# ENG-CDR20001-R5-TIS Summary\_Markup Summary

## Summary of Comments on TIS Redline Comments KDF & JCH.pdf

Monument Academy  
Traffic Impact Analysis  
PCD File No. U192/PPR19009  
(LSC #184820)  
March 2, 2020

Figure 4

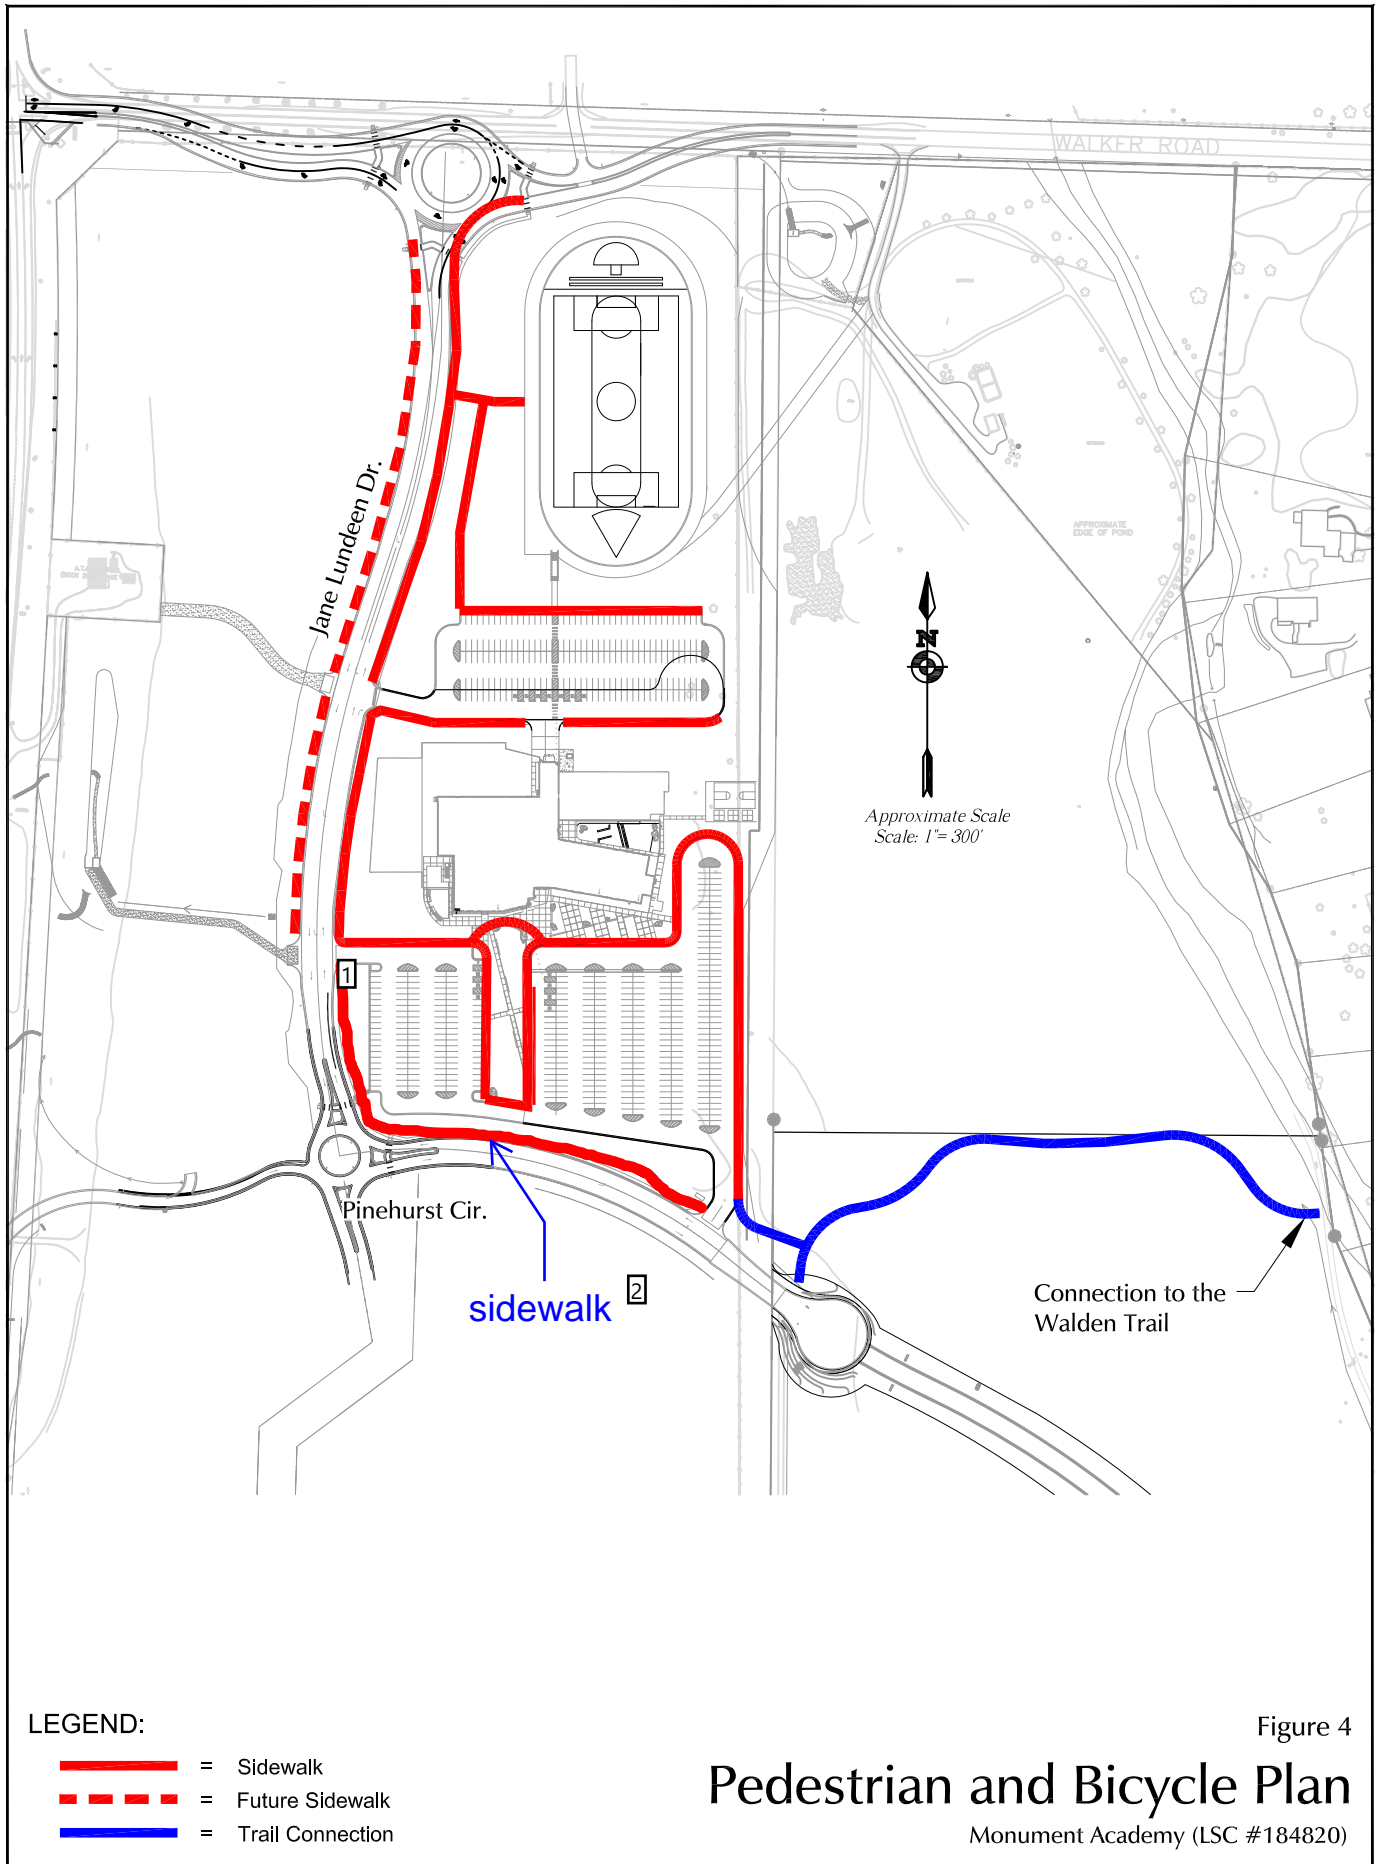
[sidewalk](#)

Author: jchodsdon      Subject: Sticky Note      Date: 4/7/2020 13:50:26  
The figure has been updated to show sidewalk per the comment.

Figure 7

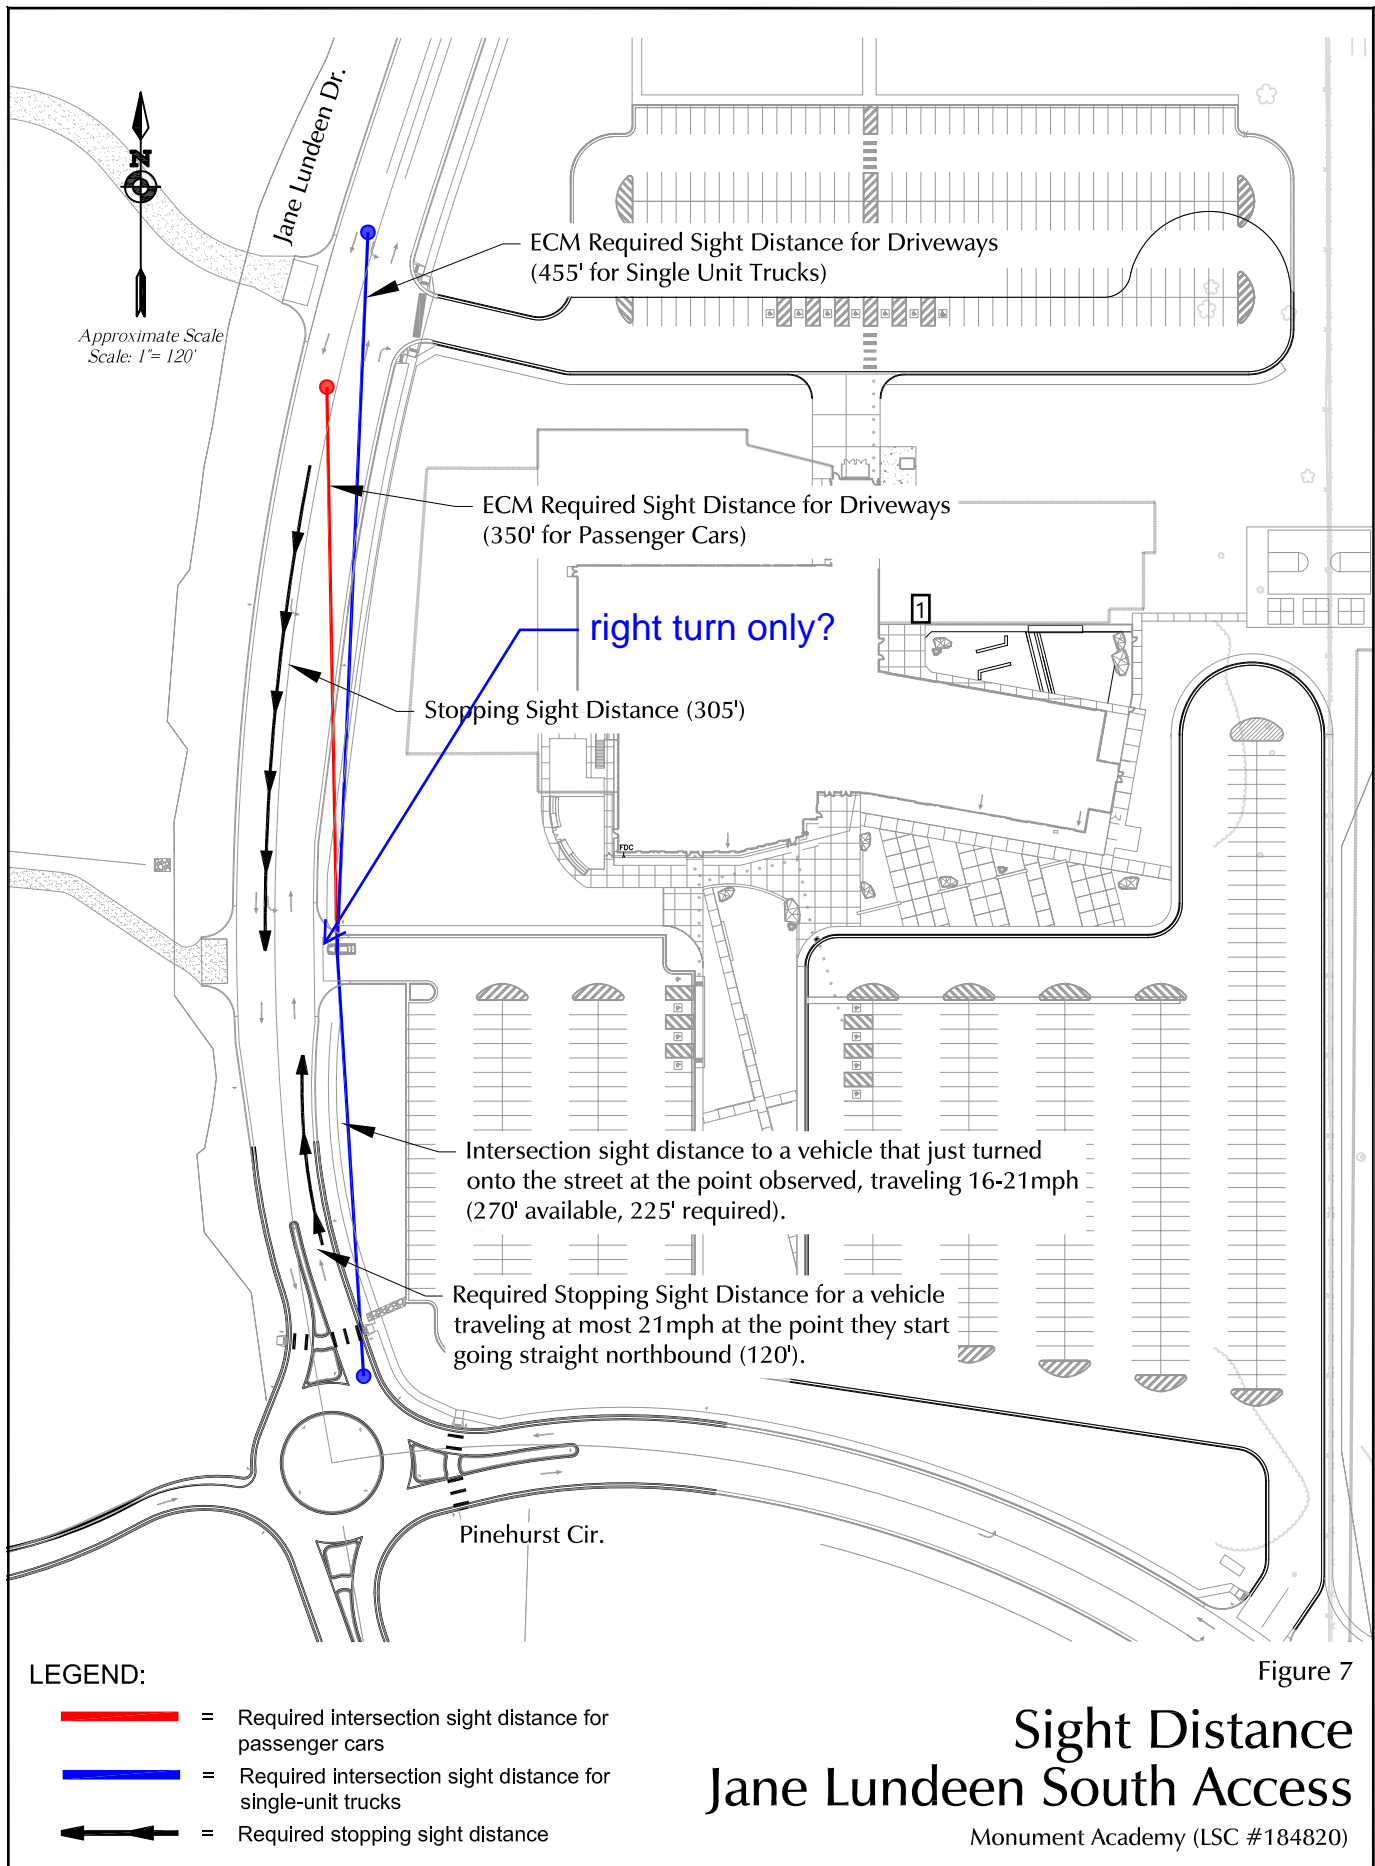
right turn only?

This access is generally planned to be a full-movement intersection. Clarification has been added to the updated TIS with language regarding the addition of a "wayfinding" sign(s) and potential turn restriction during parent drop off/pick up times (depending on the selected final carpool plan).

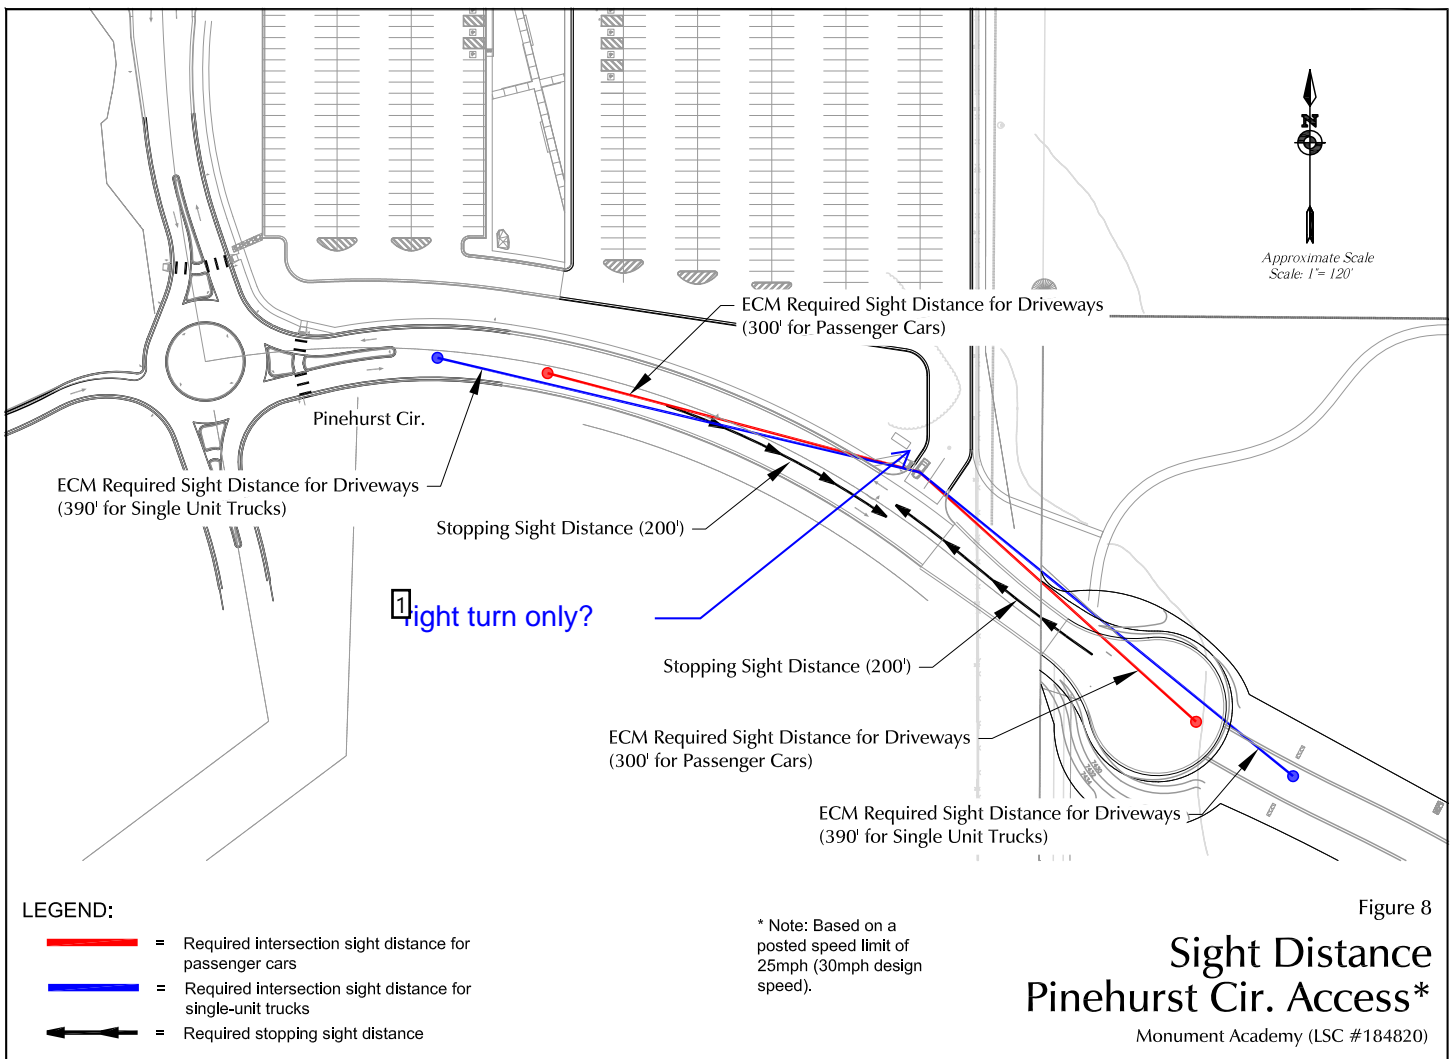
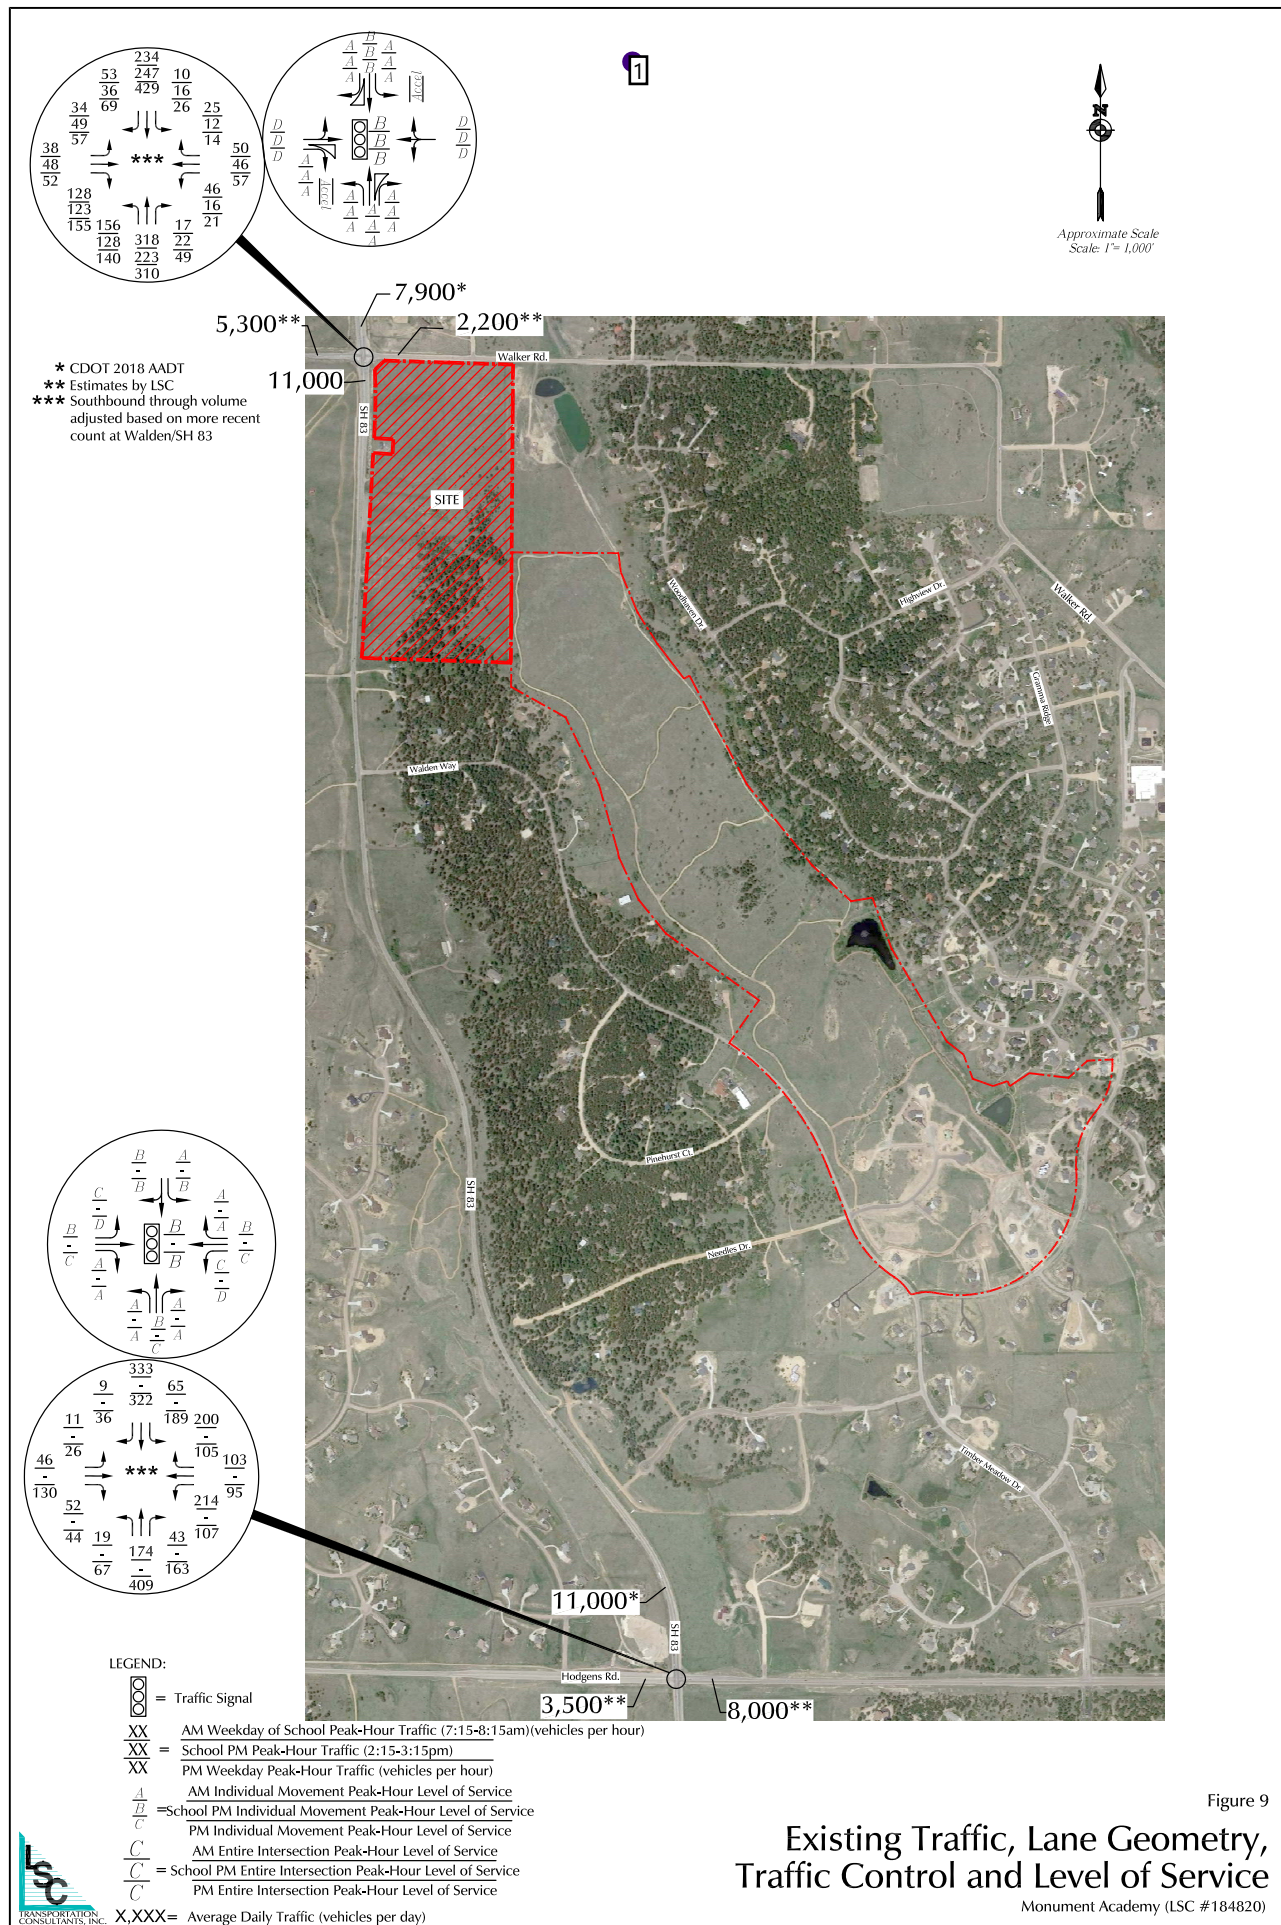
right turn only?

replace profile with sight distances

The access will be restricted using striping and signing and potentially cones or other devices during pickup/dropoff times. As exiting motorists may make exiting left-turns at this access anyway, the sight distance evaluation has been included.

Completed as requested. Please refer to Figure 8.

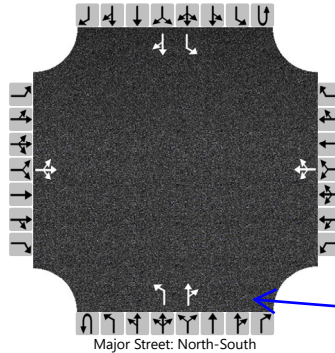
separate right turn lane?

Author: Kirstin      Subject: Sticky Note      Date: 3/31/2020 11:00:17  
The pedestrian level of service analysis has been updated to include a northbound right-turn lane

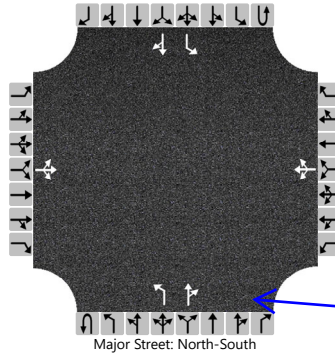
separate right turn lane?

Author: Kirstin      Subject: Sticky Note      Date: 3/31/2020 11:00:24  
The pedestrian level of service analysis has been updated to include a northbound right-turn lane
